Subject: Operations Maintenance Facility: East – Bulletin No. 0032

Bulletin No.	Description	Importance	Cost
0032	PCC Pavement at MOW	Normal	Unanticipated

PROJECT: LINK OPERATIONS & MAINTENANCE FACILITY: EAST**STANTEC PROJECT NO:** 204820133**DATE:** 12/12/2019**CONTRACT NO.:** RTA/CN 002-16**ORIGINATOR:** JIM MCPHERSON**DISCIPLINE:** CIVIL

Subject: Design bulletin DB032 for DP2 changes

DRAWING No.:
Y02-CPP202
LOCATION ID:
Y02
SHEET No.:
REV:
A

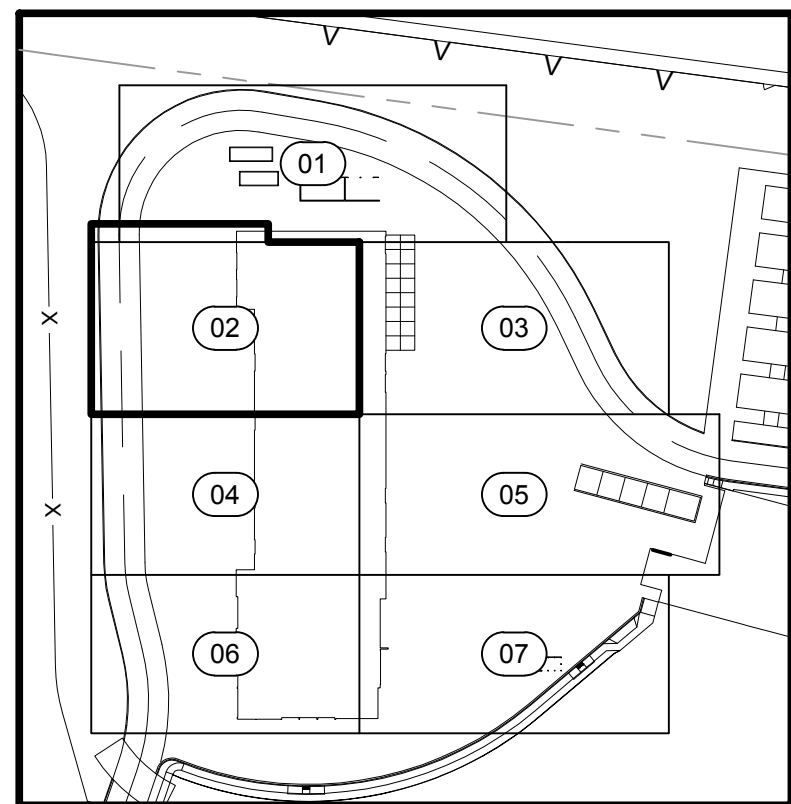
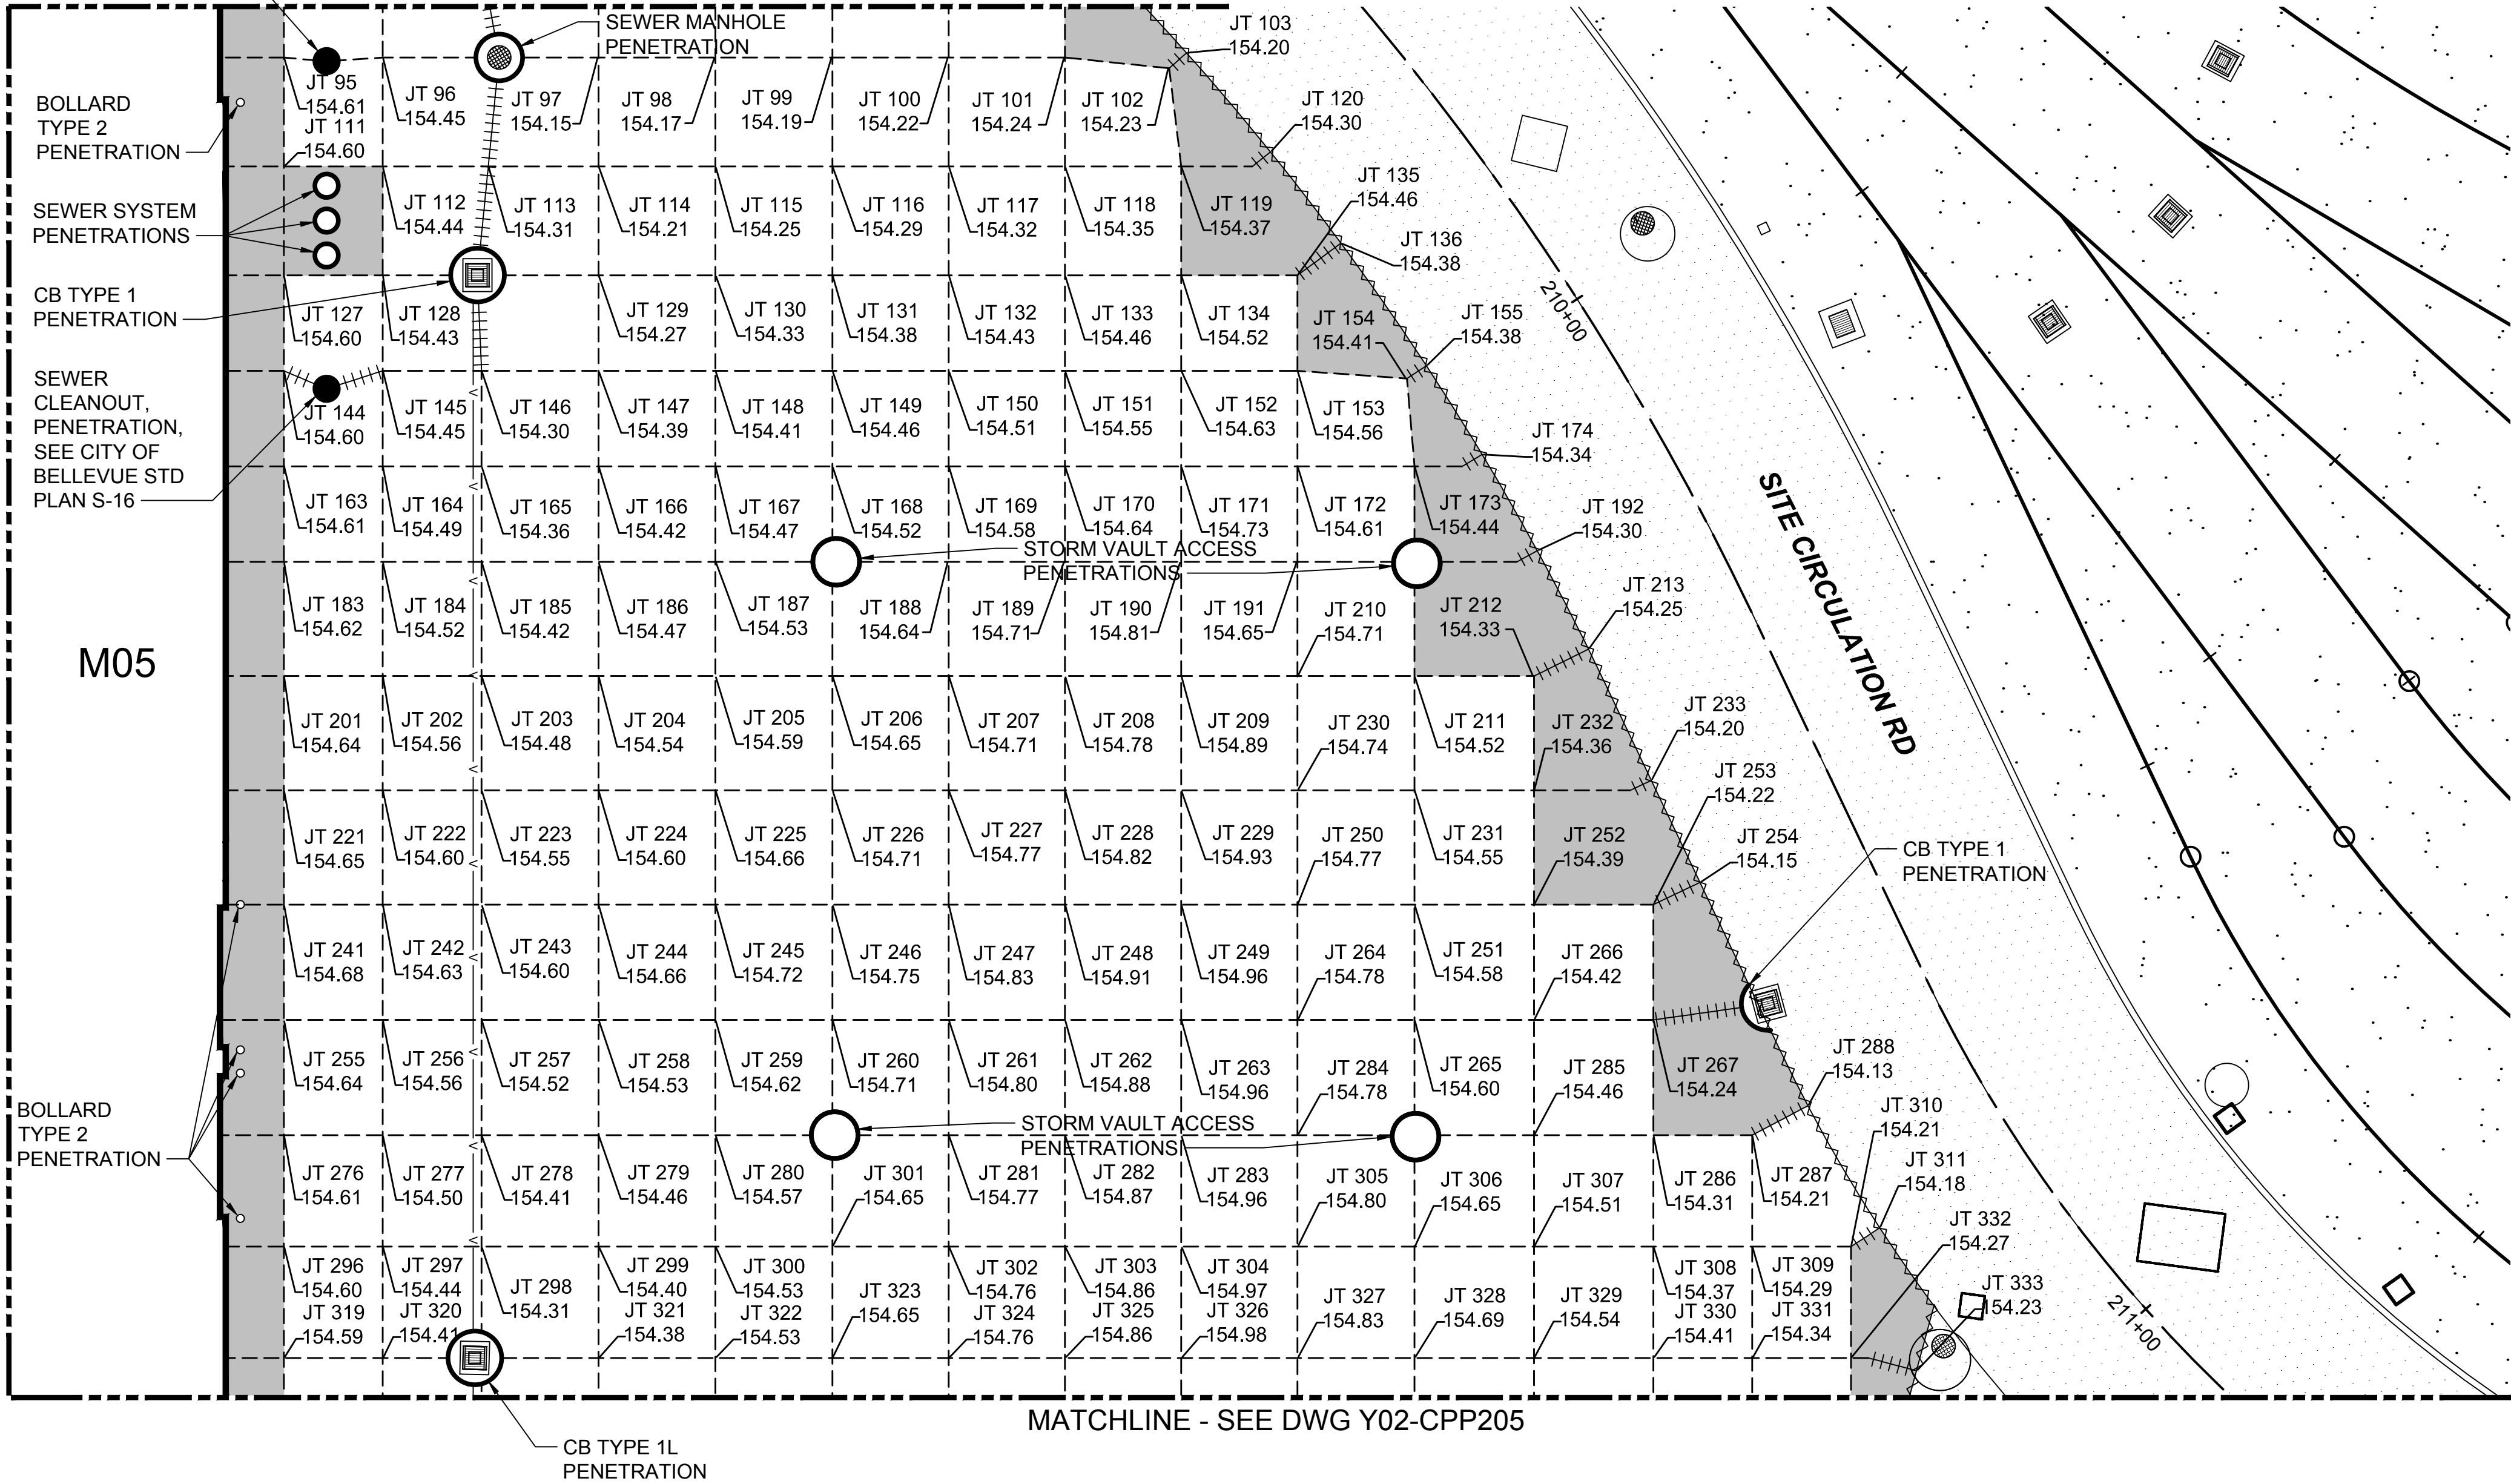
VARIOUS ELEVATION CHANGES,
SEE CLOUDS ON POINT TABLES.

DRAWING No.:	Y02-CPP204
LOCATION ID:	Y02
SHEET No.:	REV: A

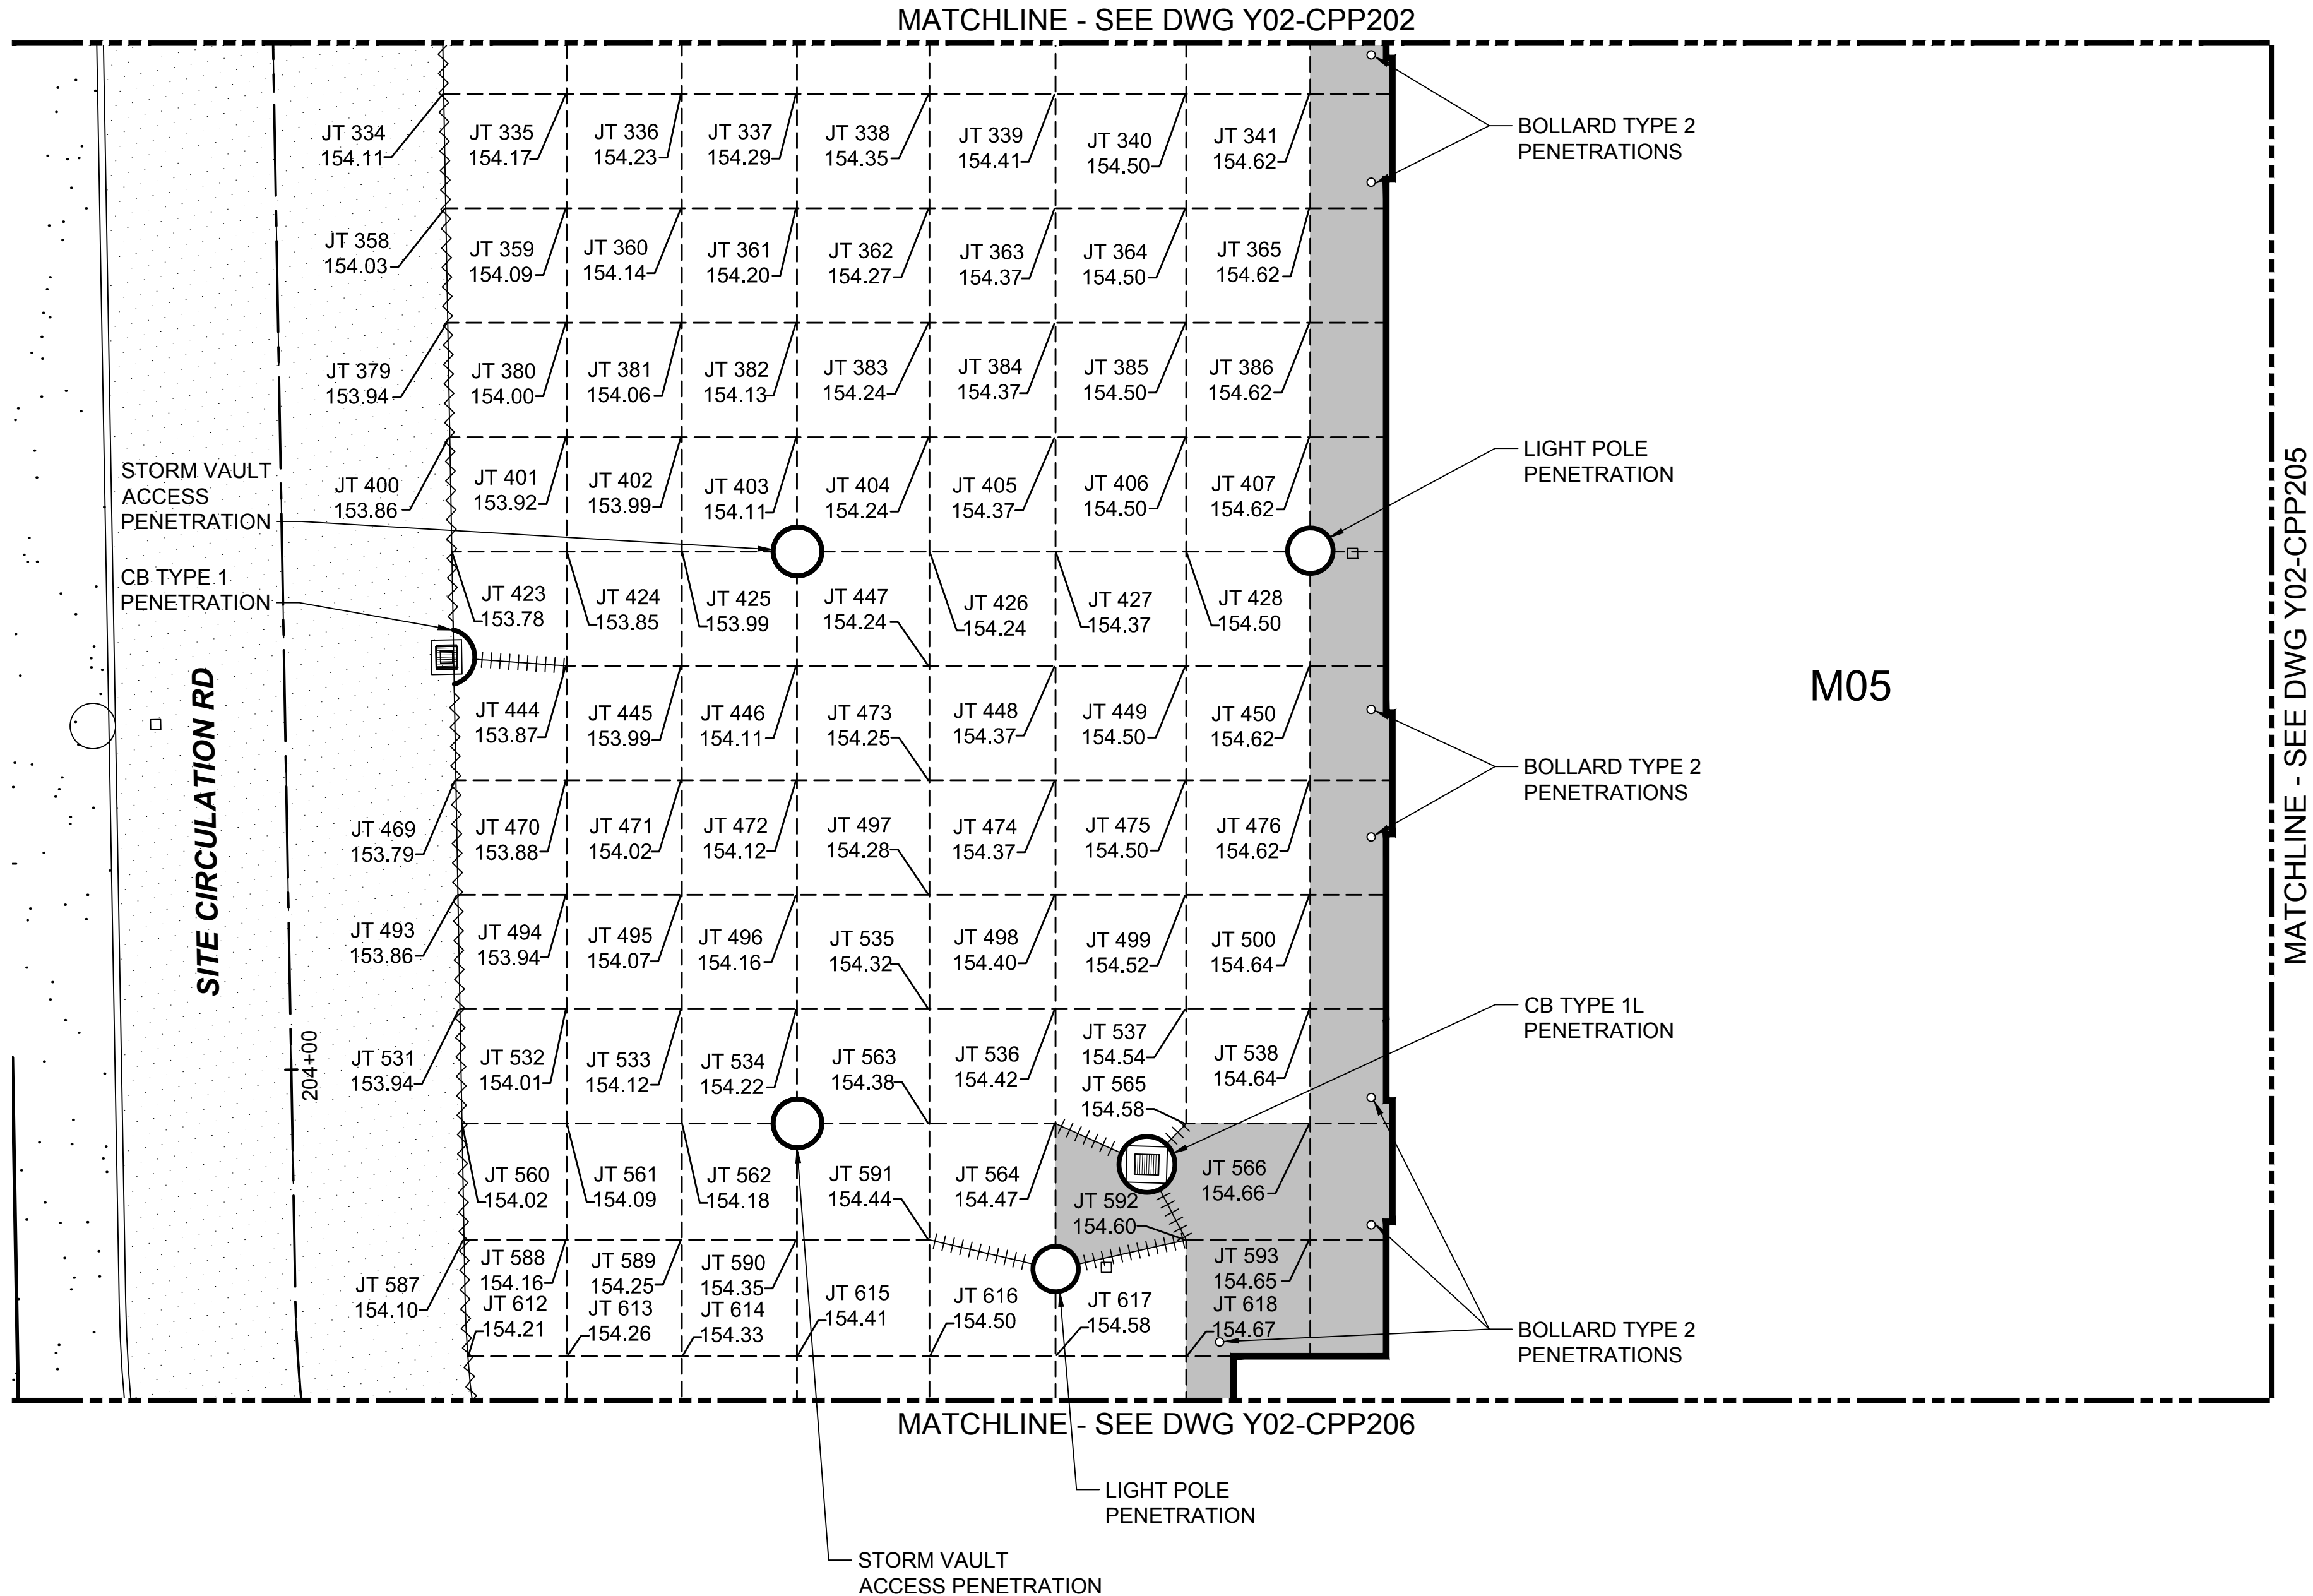
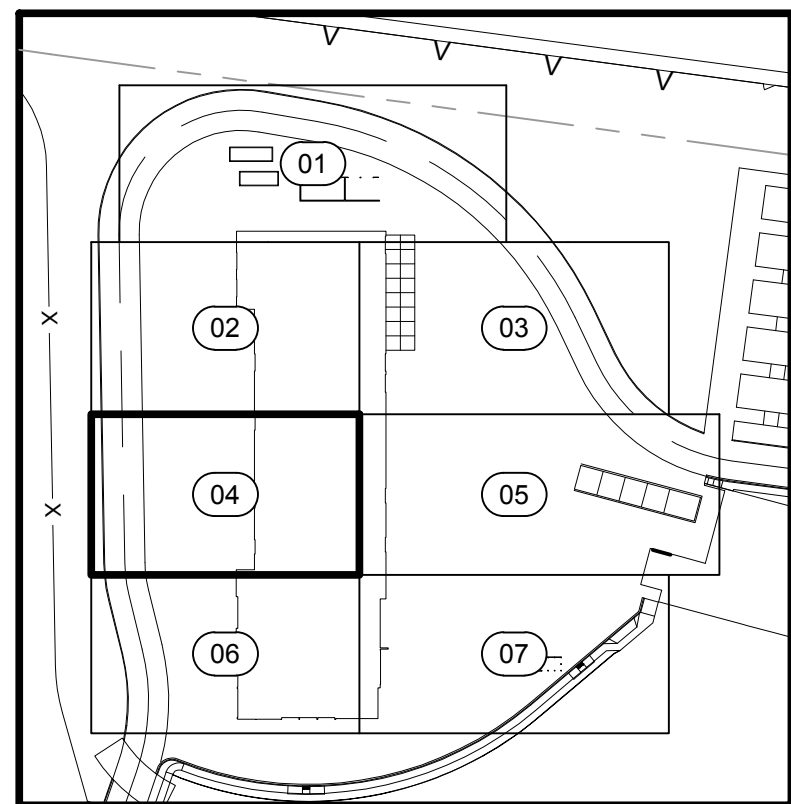
VARIOUS ELEVATION CHANGES,
SEE CLOUDS ON POINT TABLES.
